TECHNICAL NOTE

**ERNEST ORLANDO LAWRENCE
BERKELEY NATIONAL LABORATORY**

MICE Spectrometer Solenoid: Summary of Modification Plan

Figure 1: Layout of the modified cooler arrangement (5 ea 2-stage, 1 ea 1-stage)

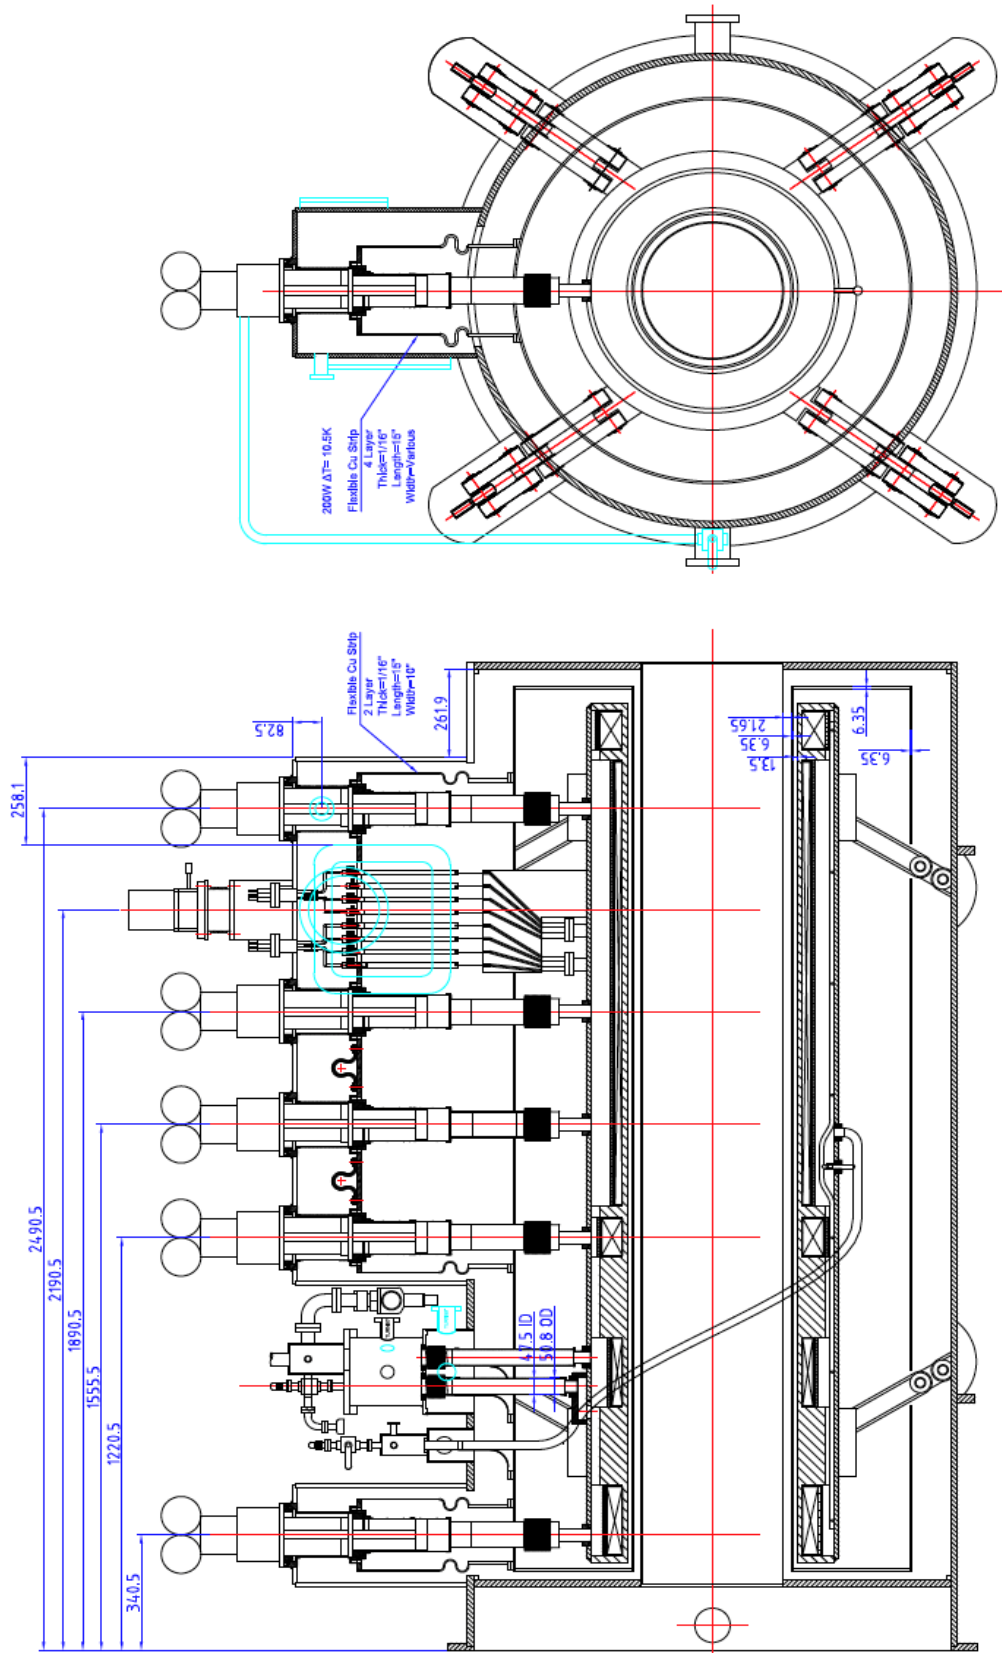
- The total cooling power is being increased by using five 2-stage pulsed tube coolers and one single-stage cooler. A layout of the modified design showing the positions of the six cryocoolers is shown in Figure 1. This drawing represents the magnet layout produced by Wang NMR. The detail drawings required for carrying out this approach have already been generated by the vendor through a PO change order.
- The thermal/mechanical stabilities of the cold leads will be improved by adding extra copper/superconductor near the cold mass feedthroughs. The added copper lead material will significantly stiffen the leads to prevent movement caused by electromagnetic forces and will provide a more effective means of cooling through conduction.
